**STAFF RECOMMENDATION**

**1017 North 16<sup>th</sup> Street**

**March 17, 2021**

**Application:** New Construction—Addition; Setback Determination

Figure 1. 1017 North 16<sup>th</sup> Street.

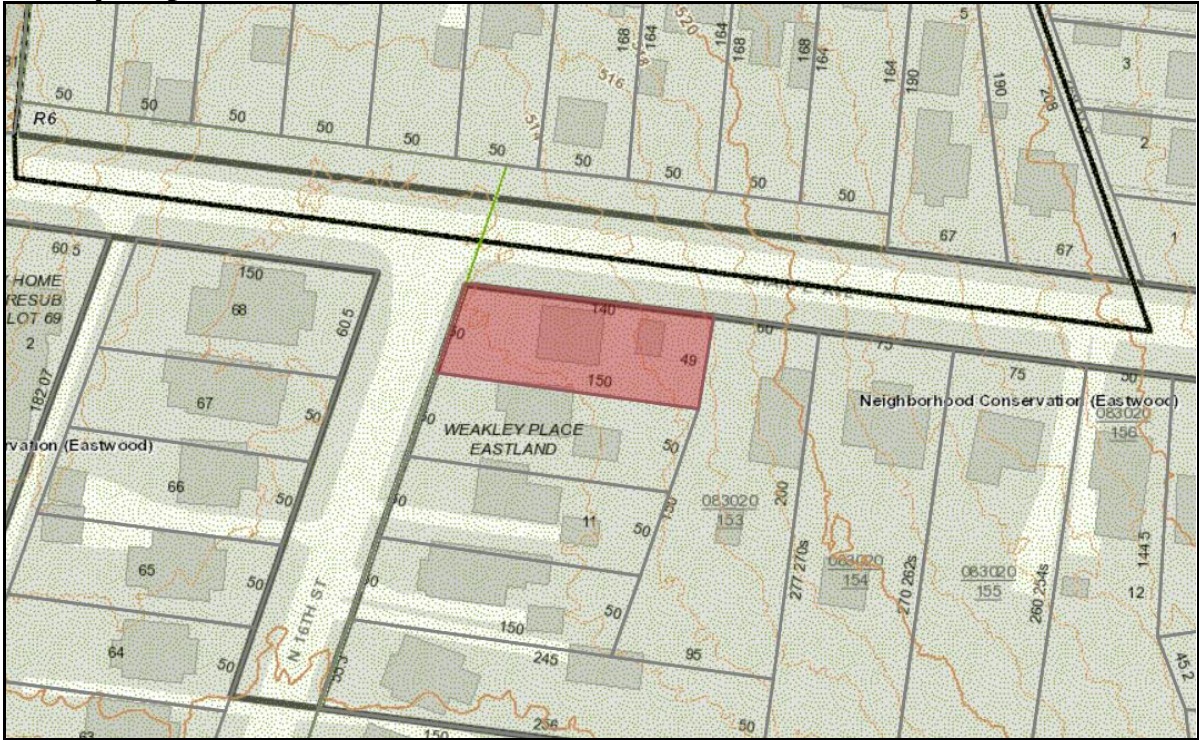
**Background:** The house located at 1017 North 16<sup>th</sup> Street was constructed c. 1947 and does not contribute to the character of the Eastwood Neighborhood Conservation Zoning Overlay due to its later date of construction (Figure 1). This month staff administratively issued a preservation permit to demolish the existing outbuilding.

**SITEPLAN-PROPOSED**

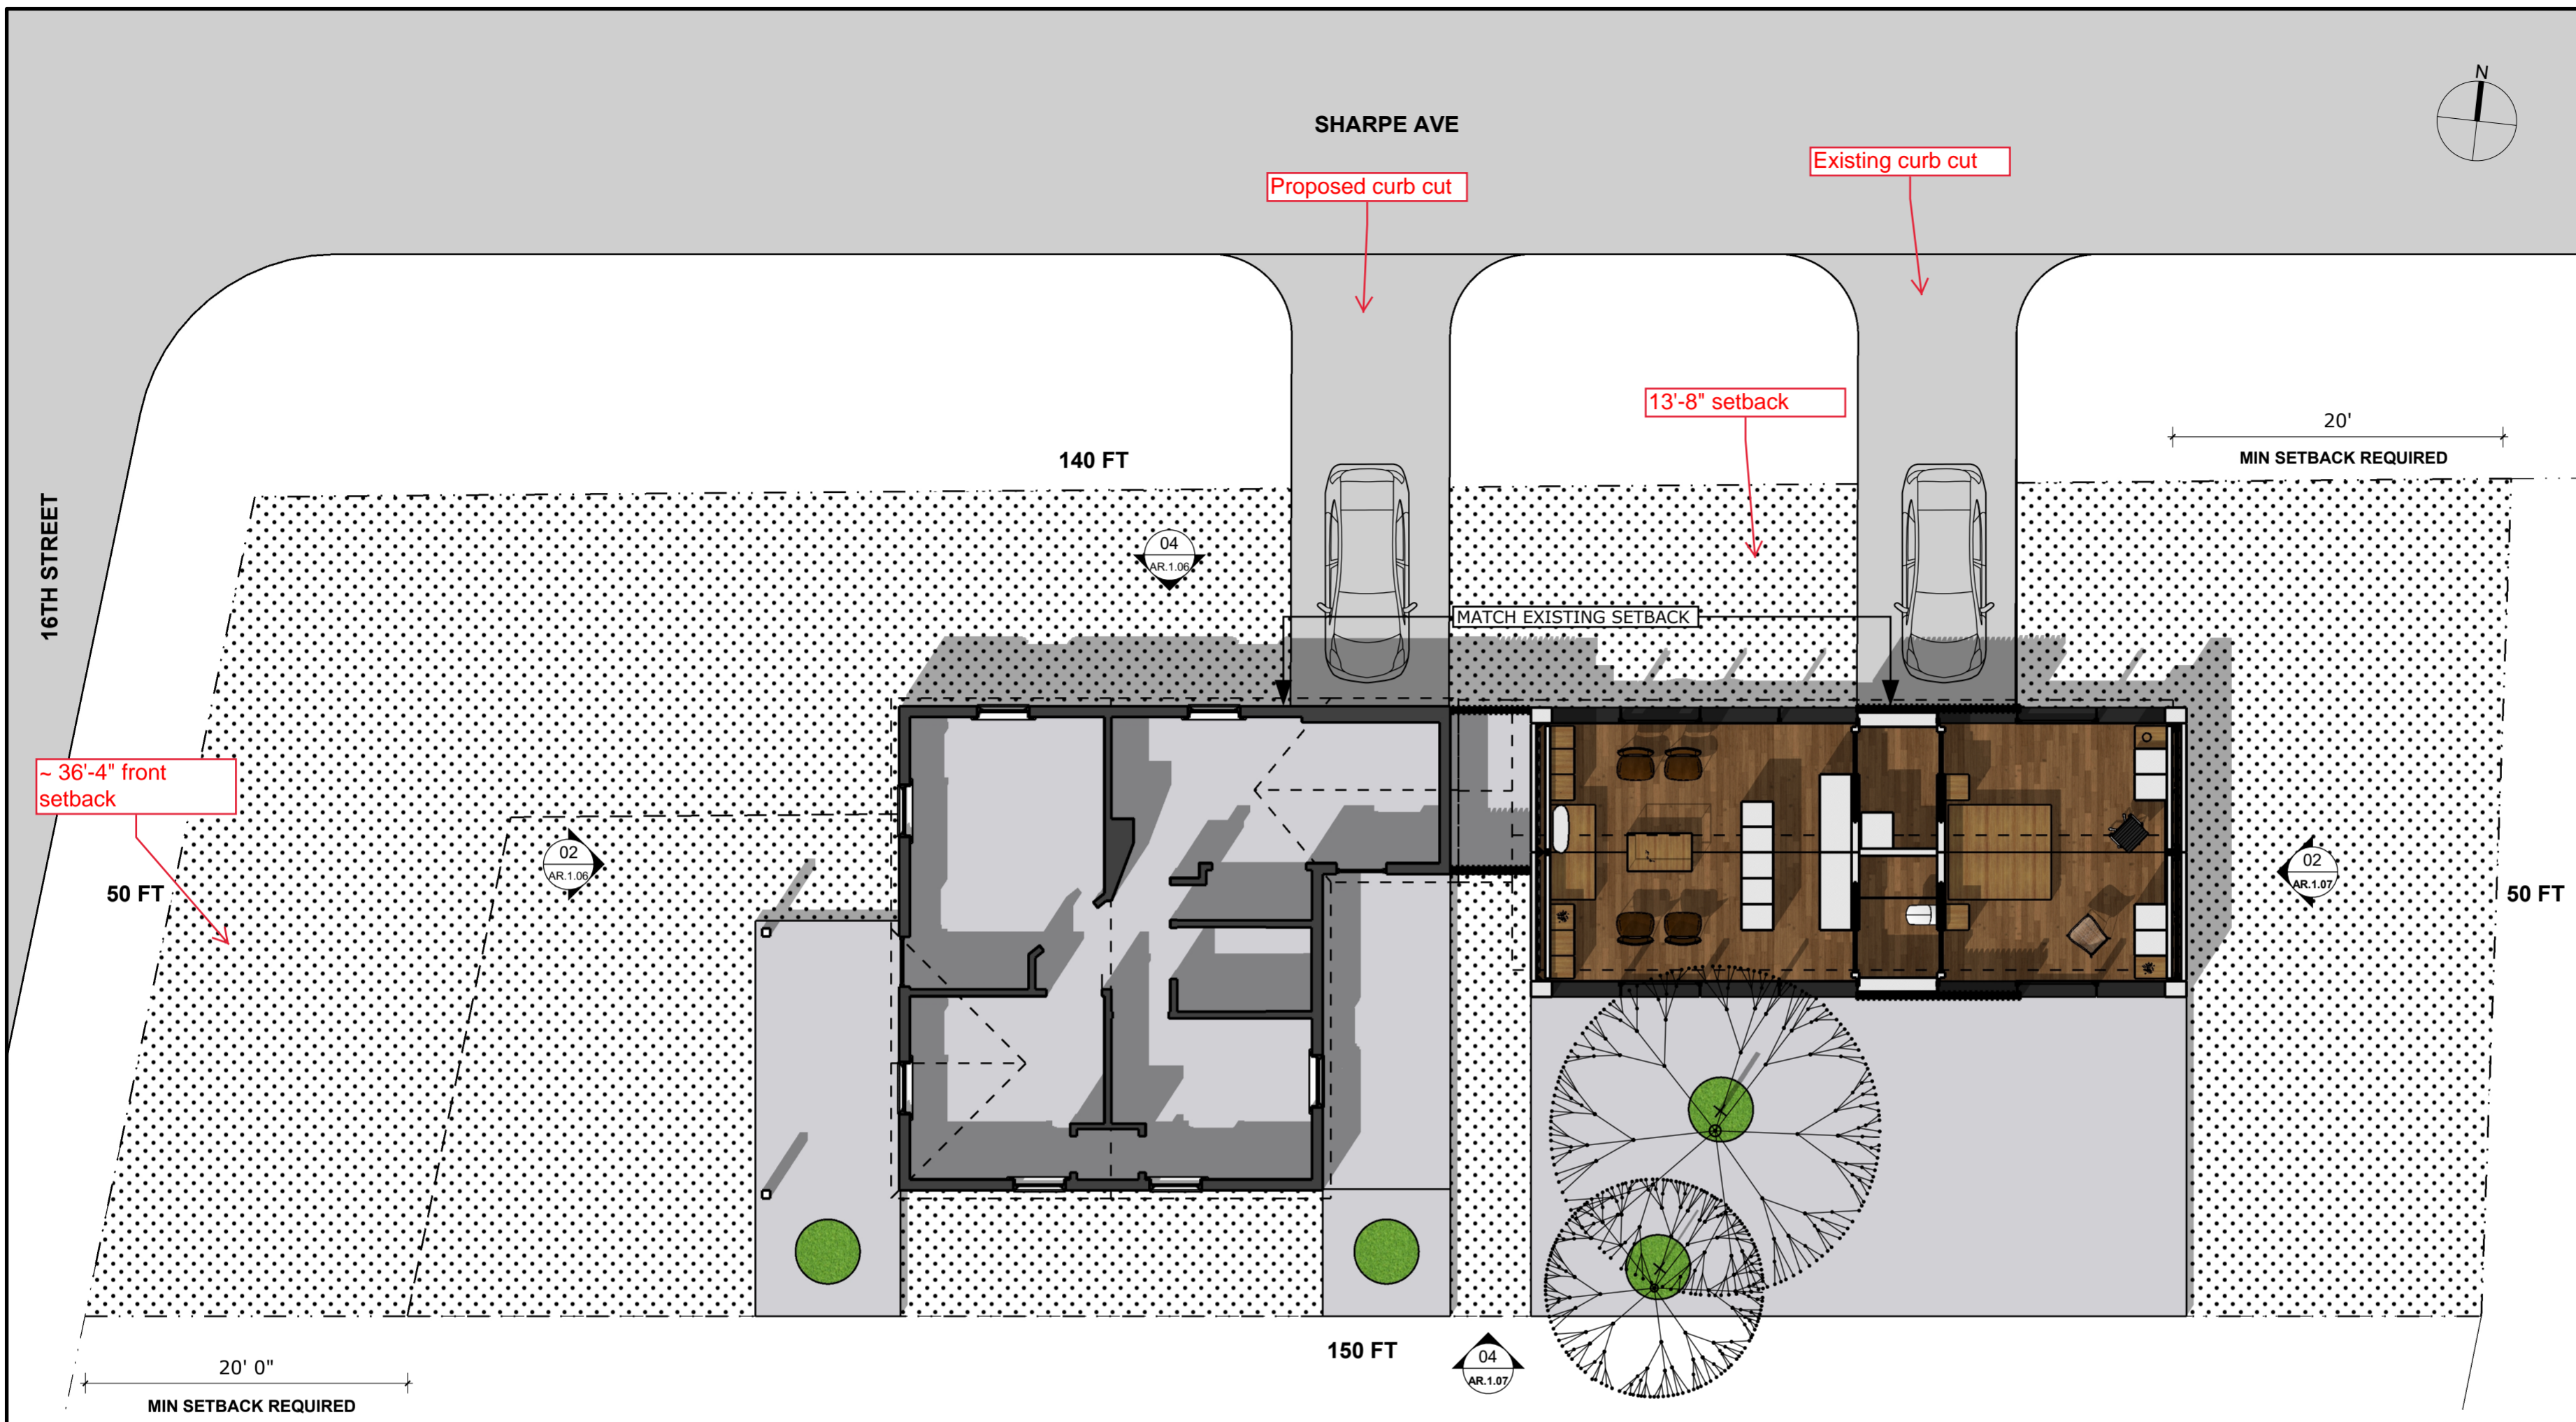
The project includes a setback determination to reduce the street setback from Sharpe Avenue from twenty feet (20') to thirteen feet, eight inches (13'-8"). Staff finds the proposed street setback to be appropriate for several reasons. The proposed rear addition lines up with the side wall of the existing house. Also, the proposed setback is similar to the house at 1020 North 16<sup>th</sup> Street, which is a similarly situated lot.

Orientation: With the proposed front porch addition, the house remains oriented to North 16<sup>th</sup> Street. The front porch has a depth of eight feet, six inches (8'-6"), which meets the design guidelines. The existing front walkway that connects the front entrance to the public street is not reflected on the plans. Staff recommends that the project include a front walkway.

Appurtenances & Utilities: The site already has vehicular access from Sharpe Avenue where the existing outbuilding is located. The plan proposes to add a second curb cut and pull-in parking closer to the intersection. Since the lot depth is less than one hundred fifty feet (150'), Public Works only permits one curb cut. Staff recommends that the existing curb cut be removed and that a new curb cut and parking for both units be located at the rear of the addition.

The location of the HVAC and other utilities was not noted. Staff asks that the HVAC be located on the rear façade, or on a side façade beyond the midpoint of the house.

With the condition that the site plan include a front walkway connecting the front entrance to the public street, staff finds that the project can meet Section II.B.1.f.

With the condition that vehicular access and parking be relocated to the rear yard, staff finds that the project can meet Section II.B.1.i.
